NJSEA Arena Painting of Exterior Towers

East Rutherford, New Jersey

ADDENDUM #1

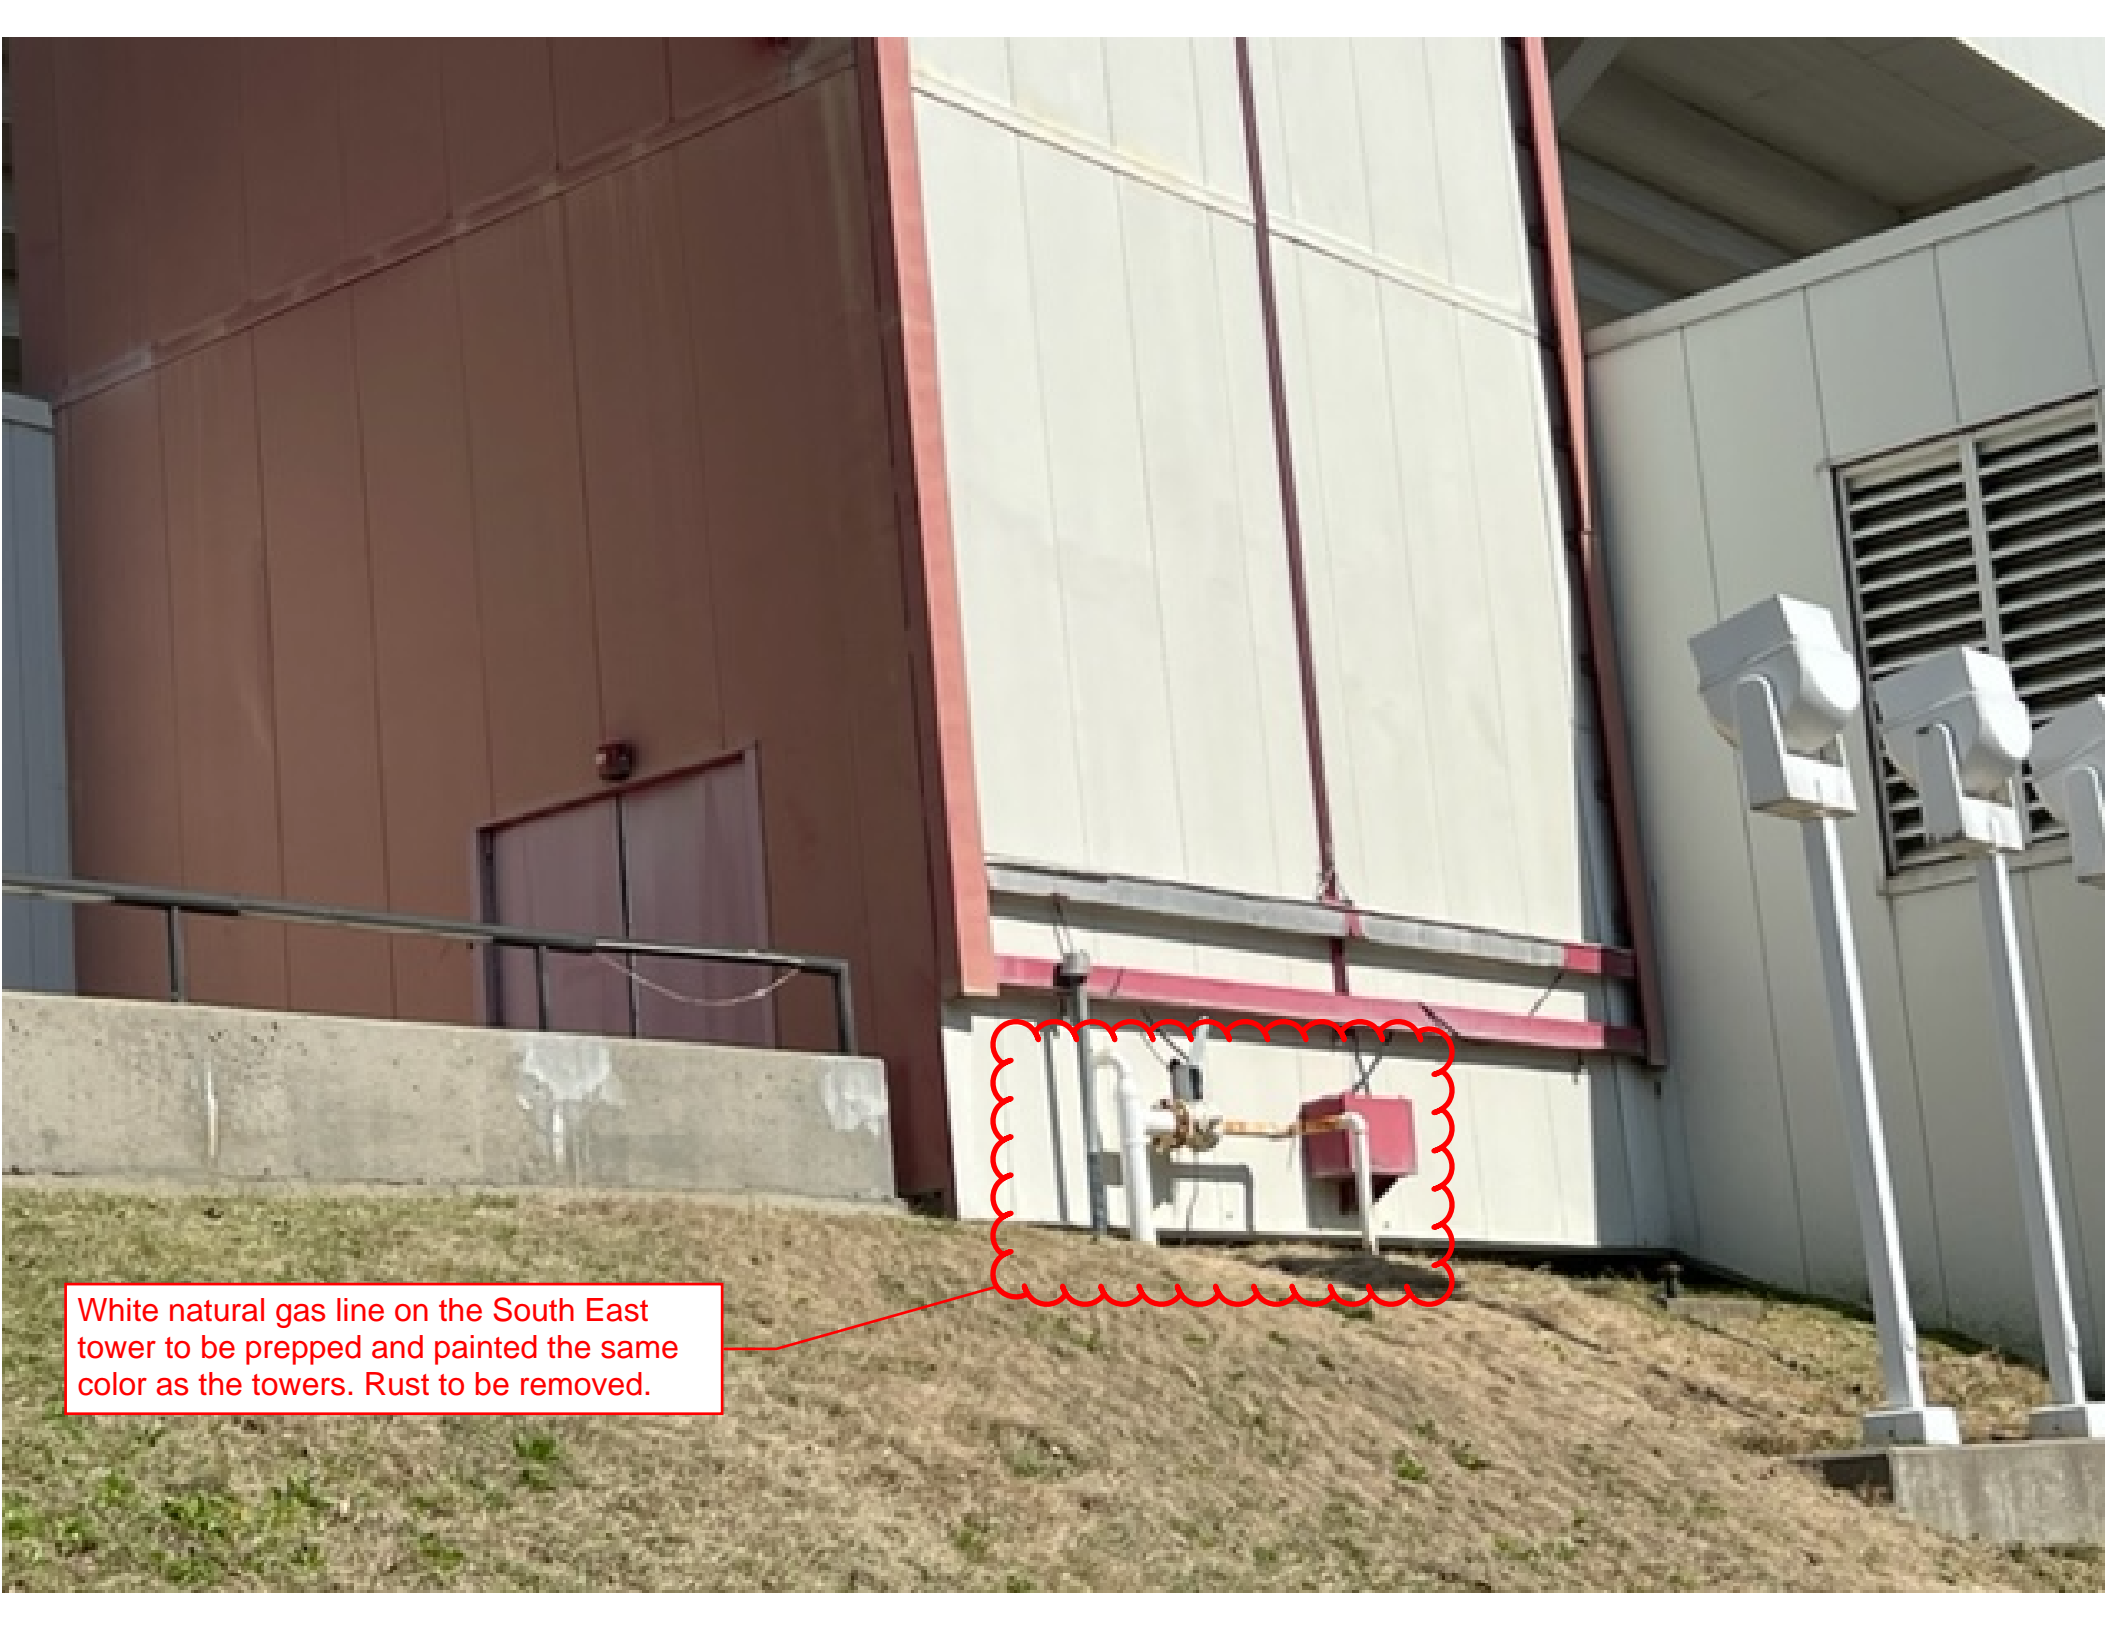
White natural gas line on the South East tower to be prepped and painted the same color as the towers. Rust to be removed.

Red vertical guide, red brackets at the corners of the column, and the white face of the column to be prepped and painted as per the project specifications.

Two horizontal members, cable box, and cable will be removed prior to commencement of work.
